Rio Algom Mining LLC

Subject: **License SUA-1473, Docket 40-8905
Pond 2 Cell Design Plan Revision**

Pond 2 Cell Design Plan Revisions

ADDITIONS/CHANGES TO REVISION 1 RECLAMATION PLAN TAILINGS CELL 2, Dated May 2007

FIGURE 7.2

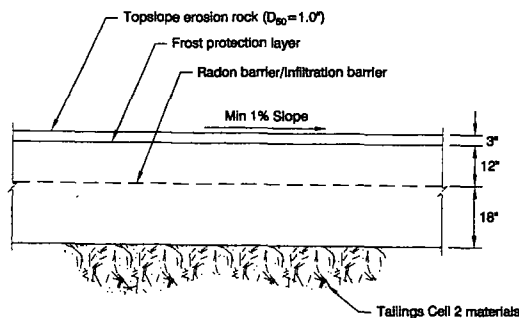
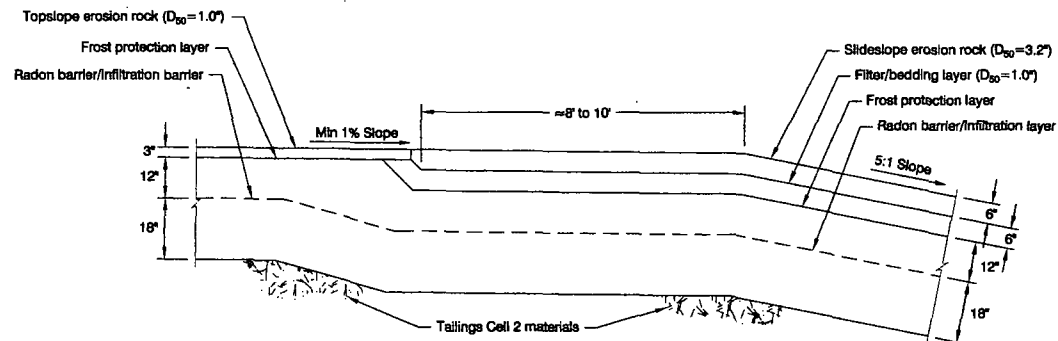
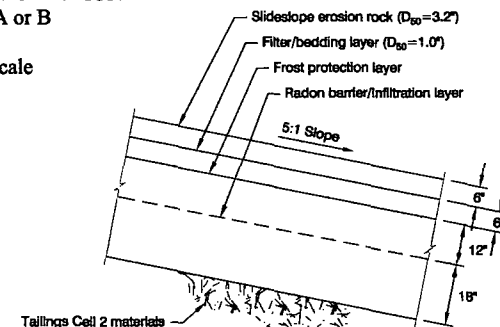
Revised drawings are included with this submittal. Revisions consisted of correcting a typographical error on 7.2 and removing the gradation tables from the drawings.

2. The erosion protection for the topslope of Pond 2 shall be constructed of a rock diameter $d_{50}=1.0''$ conforming to the gradation as presented on Table 7.4.

3. The slideslope erosion protection of Pond 2 shall be constructed of a rock diameter $D_{50}=3.2''$ and shall be placed on a minimum 6" thick filter/bedding layer, and conform to the gradation as presented on Table 7.4.
